ITEM E2 - MCCLAREN SUBDIVISION

KPB File # 2016-083

ITEM 2 - MCCLAREN SUBDIVISION

STAFF REPORT

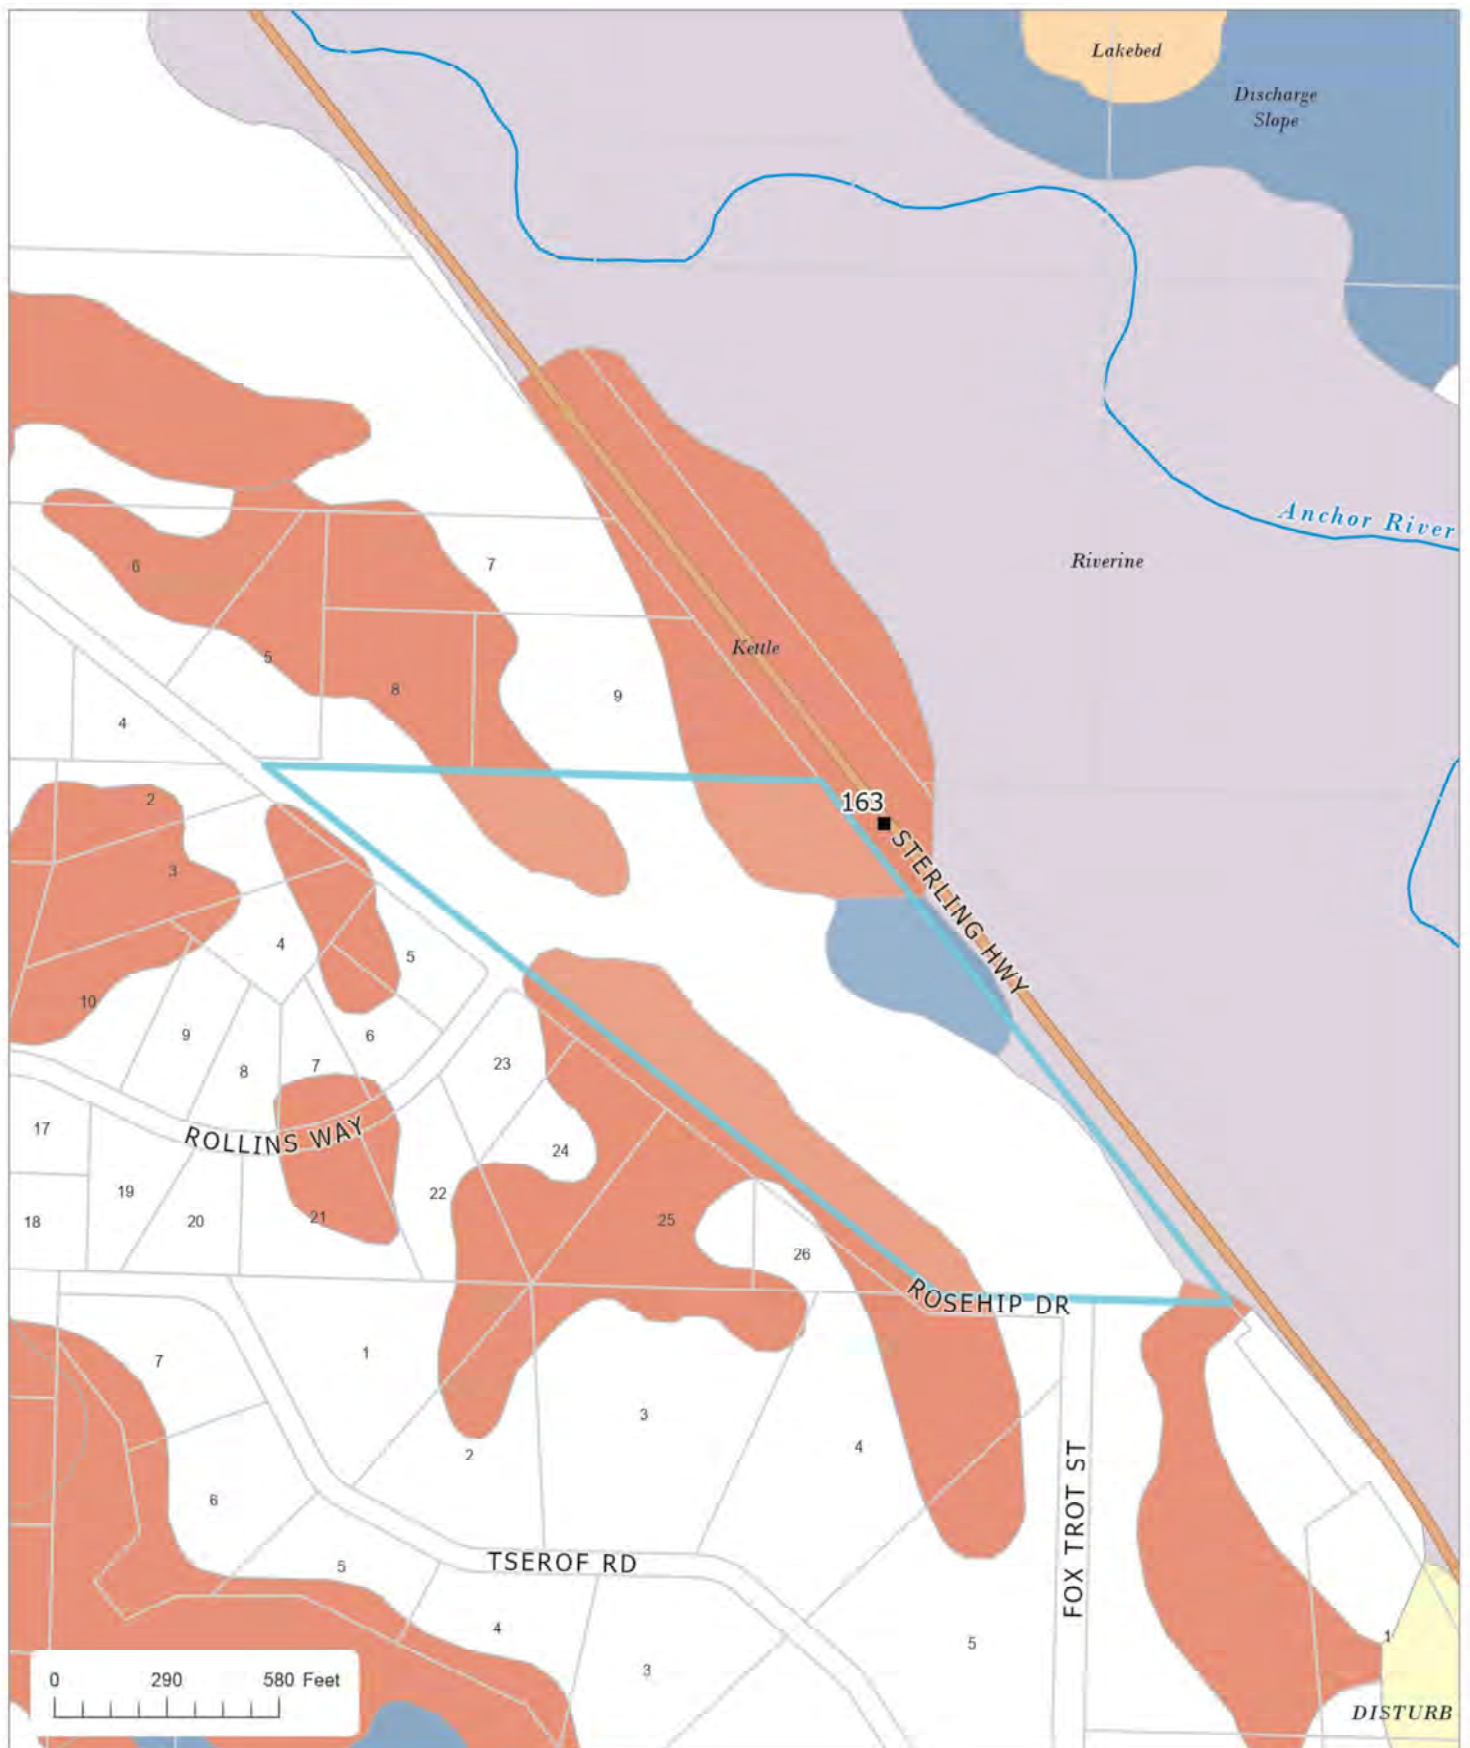
1. Correct the label for HM 86-77
 2. Clarify Lot 4 to the northwest is part of HM 86-77.
 3. Revise the label to the south. The unsubdivided remainder of A to S Subdivision adjoins the proposed plat.

5. Label the existing dedication for Rollins Way.
- L. Contours at suitable intervals when any roads are to be dedicated unless the planning director or commission finds evidence that road grades will not exceed 6 percent on arterial streets, and 10 percent on other streets;
Platting Staff Comments: Additional information was requested from the surveyor (July 26th) to confirm the right-of-way being dedicated by this plat complies with 20.25.070 and 20.30.090.

*If the owners wish to grant the waterline easement by this plat, **staff recommends** compliance with 20.60.160, and the easement be labeled 'granted this plat.' Removal of the platted easement will require Planning Commission review and approval.*

Staff recommends wording be added to the 10-foot easement to HEA to clarify if it is an existing easement or it is being granted this plat. If the HEA easement is existing, **staff recommends** the recording information be noted on the plat if the easement was recorded.

1. *Correct the spelling of Mrs. McClaren's name in the Certificate of Ownership and the Notary's Acknowledgement.*
2. *Provide the Plat Approval statement.*
3. *Include the engineer's wastewater disposal certificate.*
